Appln. No. 09/825,910
Amdt. dated Mar.24, 2004
Reply to Office communication of Sep. 24, 2002
Docket 14XZ00098

Remarks/Arguments

Status of the Drawing:

FIG. 4

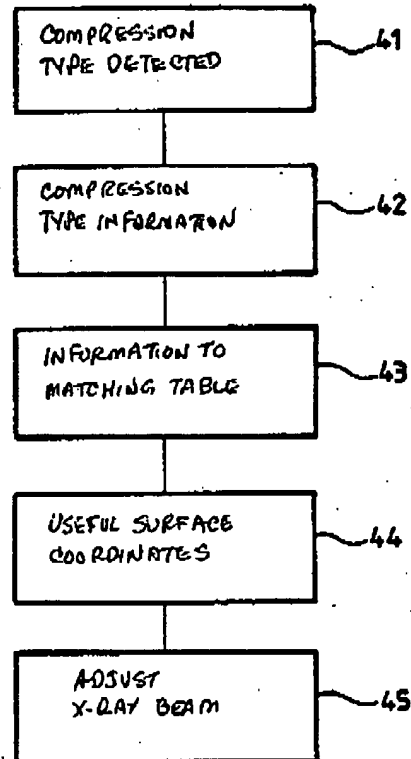
In response to the drawing requirement, Figs. 4 and 5 have been amended to show the legends for the block symbols.

LEGENDS ADDED
TO BLOCK SYMBOLS
